RE: 2025-15 Marriott Hotel Site Plan Review

Testimony for the public hearing December 1, 2025

To the City of Hood River Planning Commission:

ATTACHMENT C – existing buildings with 2:1 building square feet to site square feet ratio

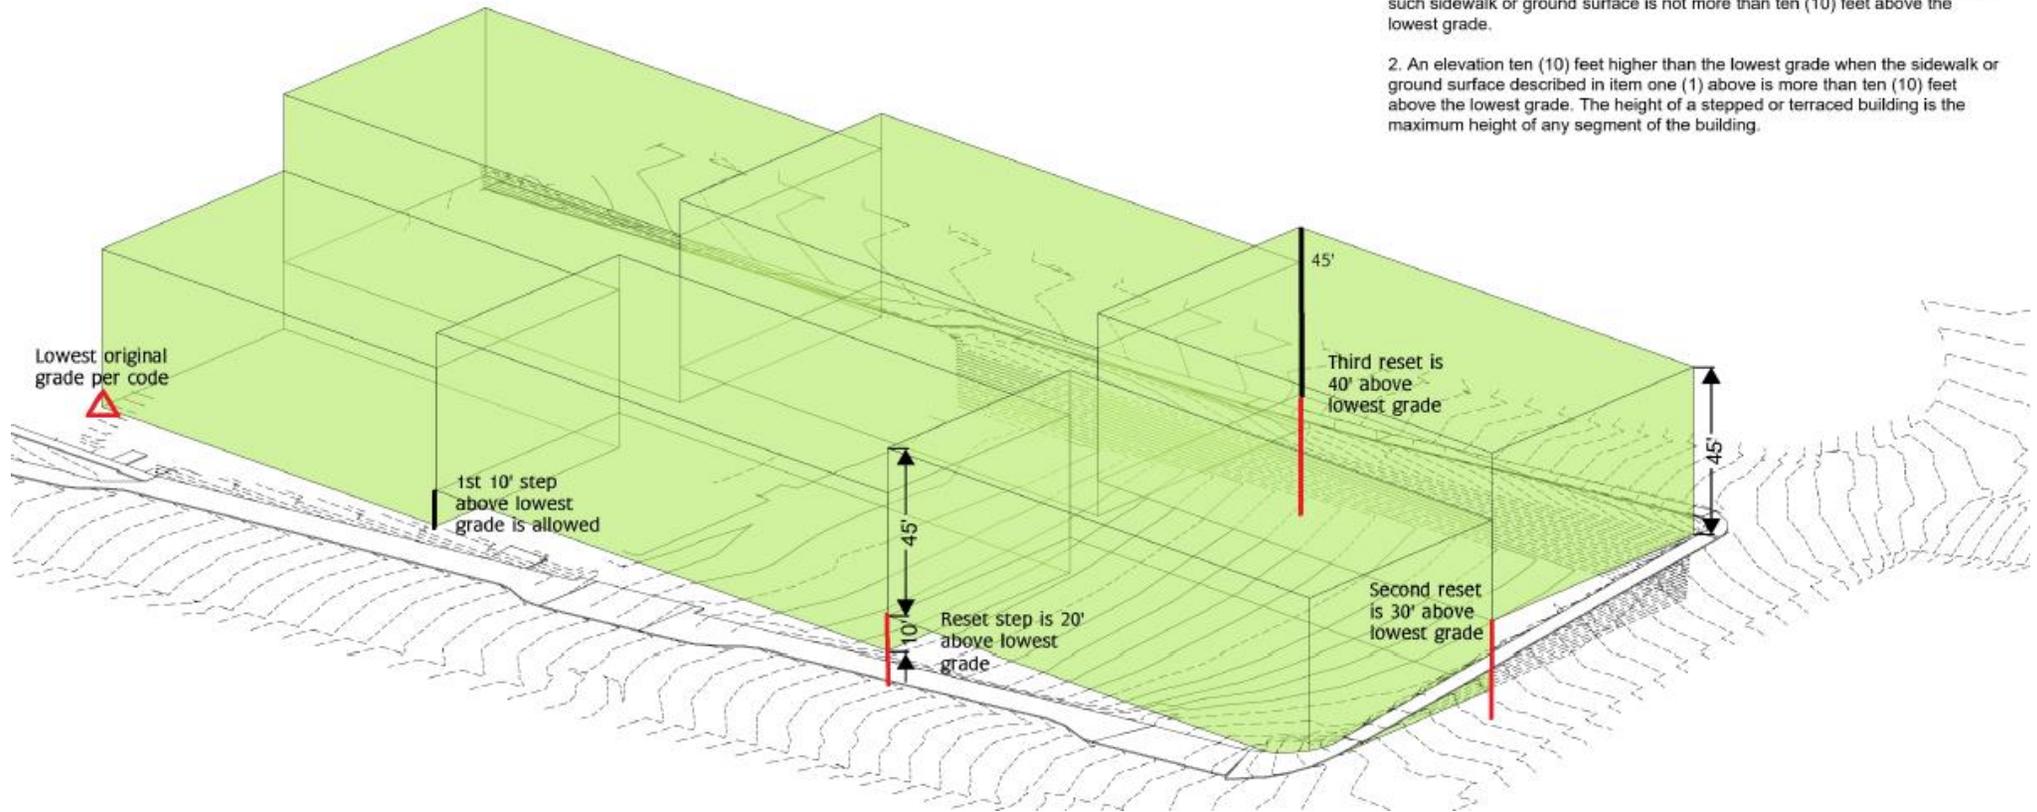
In the Walmart case, the county defined bulk as enclosed cubic feet. It seems disingenuous for the City to create an interpretation of bulk that differs from the Walmart case which they defended to LUBA, but that is what's happening. The staff report for this project defined bulk as the *ratio of the square footage of the building to the square footage of the site*, deriving a 2:1 ratio. By that measure, any two-story structure which covers all the available ground has the same bulk as this proposed building. This "relative-to-something-else approach" is not a reasonable interpretation. Attachment C shows two nearby buildings on Oak Street which have a 2:1 ratio, but would never be perceived as having the same bulk as the proposed project.
